HISTORIC RESOURCES PRESERVATION BOARD REPORT

HRPB Project Number 23-00100149: Consideration of a Certificate of Appropriateness (COA) to demolish the front of the principal structure to allow for the construction of a new front addition, to construct a new rear addition, to increase the total building lot coverage through the Sustainable Bonus Incentive Program, and to convert an existing garage to a cabana at **1405 South Palmway**. The subject property is a contributing resource to the South Palm Park District and is located in the Single-Family Residential (SFR) Zoning District.

Meeting Date: July 12, 2023

Address: 1405 South Palmway

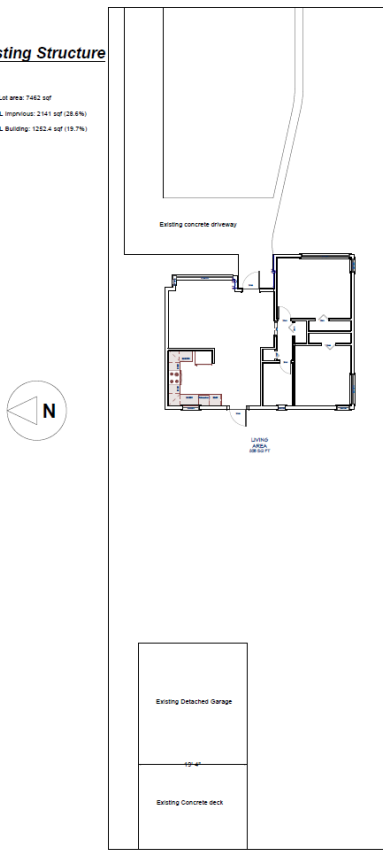
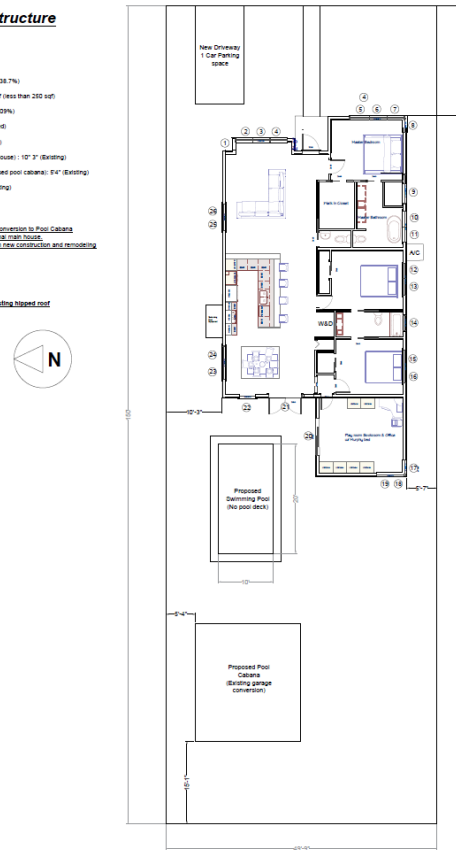
- Additions: No, the proposed front addition is not an appropriate expansion according to the Historic Preservation Design Guidelines (see below). There is 72 feet of space between the existing rear façade of the structure and rear property line, which could allow for an addition and a pool without demolition of the front façade of the principal structure (see below). The applicants are proposing a small rear addition to the primary structure; staff contends that the full addition could be placed on this elevation, preserving the historic fabric of the front façade. Further, the proposed addition does not differentiate the proposed work from the historic building, and instead tries to falsify history by portraying the new addition as the historic front façade of the house. Finally, the location of the front addition is highly visible from South Palmway.

- Addition: Yes, the original qualities and characteristics of the building will be destroyed in the proposed front addition. The applicants propose to tear down and rebuild the front façade, which is the most prominent elevation of the structure and has distinctive architectural features indicative of the Masonry Minimal Traditional architectural style. Furthermore, reconstruction of the front façade is meant to be a last resort for preservation. The existing façade is not in such a state of disrepair that reconstruction is required to preserve the structure. Staff contends that the historic character-defining features of the building can be best maintained if additions to the structure are placed to the rear of the property and are differentiated from the historic building.

- Addition: No, the front addition is not visually compatible with the neighboring properties since it will remove and alter the primary façade of the historic structure. Furthermore, the proposed front addition will interrupt the rhythm and consistency of the neighborhood by altering the front setback at 1405 South Palmway. The west side of the 1400 block of South Palmway has a consistent front setback amongst all the houses; the proposed front addition would make 1405 South Palmway's front façade closer to the street than the rest of the houses on the block.
- Cabana: Not applicable. The accessory structure is not visible from a public right-of-way.

- Addition: The proposed front addition is not compatible with the Historic Preservation Design Guidelines standards and recommendations for new additions. The proposed front addition will destroy the front façade of a contributing structure, falsify history by rebuilding the front façade, and the proposed addition does not attempt to distinguish the addition from the historical structure.

The proposed front addition is not consistent with the Historic Preservation Design Guidelines requirements, since it will contribute to the loss of historic character by destroying character-defining features, proposes reconstruction for a structure that is in good condition, and is highly visible from a public right-of-way. The proposed front addition could be constructed in the back of the structure (west elevation) since there is 72 feet of space between the rear elevation and the property line. This space could allow for a rear addition while leaving enough space for future pool in the backyard. Therefore, staff recommends denial of the front addition to the principal structure. As staff is recommending denial, no conditions of approval have been provided for the addition.

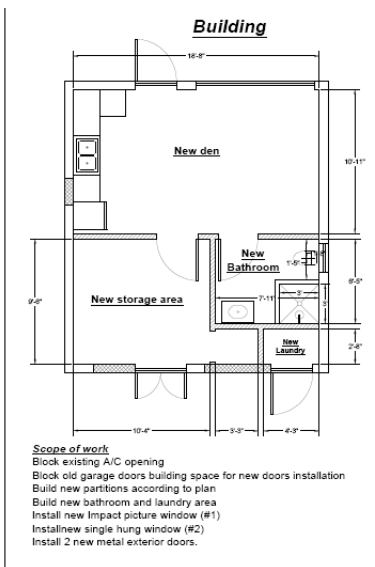
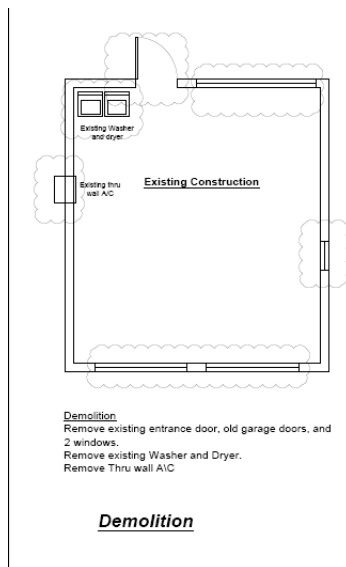
- Cabana: No, the proposed filling in of the original garage door openings is not appropriate according to the Historic Preservation Design Guidelines. In general, all windows and doors are should be installed in their existing openings; the Design Guidelines discourage filling in existing openings to accommodate alternately sized products. The proposed alterations will not imitate the appearance of a garage, nor will they leave a recessed area to exemplify the historic function of the space.

- Cabana: Yes, the original qualities and characteristics of the garage are being destroyed by incompatible alterations to the historic garage door openings. Garage door openings are one of the most character-defining features of a garage structure; the proposed alterations will fill in the garage door openings without any recessed area to indicate the historic function of the structure as a garage.

- Addition: This requirement is not applicable. The proposed addition is rebuilding the front façade windows with identical width and height dimensions as the original façade.
- Cabana: The applicant is proposing to substantially modify the original garage door opening sizes. While the sizes of the proposed entry doors may be in harmony with entry doors throughout the district, the enclosure of the garage doors is not a compatible alteration.

- Cabana: The proposed cabana is not compatible with the Historic Preservation Design Guidelines standards for windows and doors, as the existing garage door openings will be filled in to accommodate alternatively sized products. Furthermore, the proposed alterations to the garage door openings will not leave any visual references to the historic function of the space. Staff recommends that garage enclosures in historic districts leave the existing garage door(s) in place, create faux garage door(s), or leave a recessed area in the exterior wall to show where the garage doors once existed. For the project at 1405 South Palmway, staff recommends that the applicants revise the designs to leave recessed areas (no greater than 6 inches deep) to show where the garage doors once stood.

1. The enclosed garage door openings shall be recessed up to 6 inches, showing the areas where the garage doors previously existed.
2. The exterior doors shall be single-light French doors, five-light French doors, or three panel doors, as described in the Masonry Minimal Traditional section of the Design Guidelines.
3. Window 1 shall be a fixed picture window with horizontal muntins to imitate an awning window.
4. Window 2 shall be clear single-single hung windows with four horizontal lights to imitate an awning window.

5. All divided light patterns shall be created utilizing exterior raised applied muntins. Exterior flat muntins or “grids between the glass” shall not be used.
6. All glazing shall be clear, non-reflective and without tint. Low-E (low emissivity) is allowed but the glass shall have a minimum 60% visible light transmittance (VLT) measured from the center of glazing. Glass tints or any other glass treatments shall not be combined with the Low-E coating to further diminish the VLT of the glass.
7. Original window trim, window sills, and mullions shall be retained. Where original trim and surrounds need to be replaced due to severe deterioration, the replacement elements shall match what is being removed in profile, design, shape, size, configuration, and location.
8. All windows and doors shall be installed recessed in the jambs and shall not be installed flush with the exterior wall.
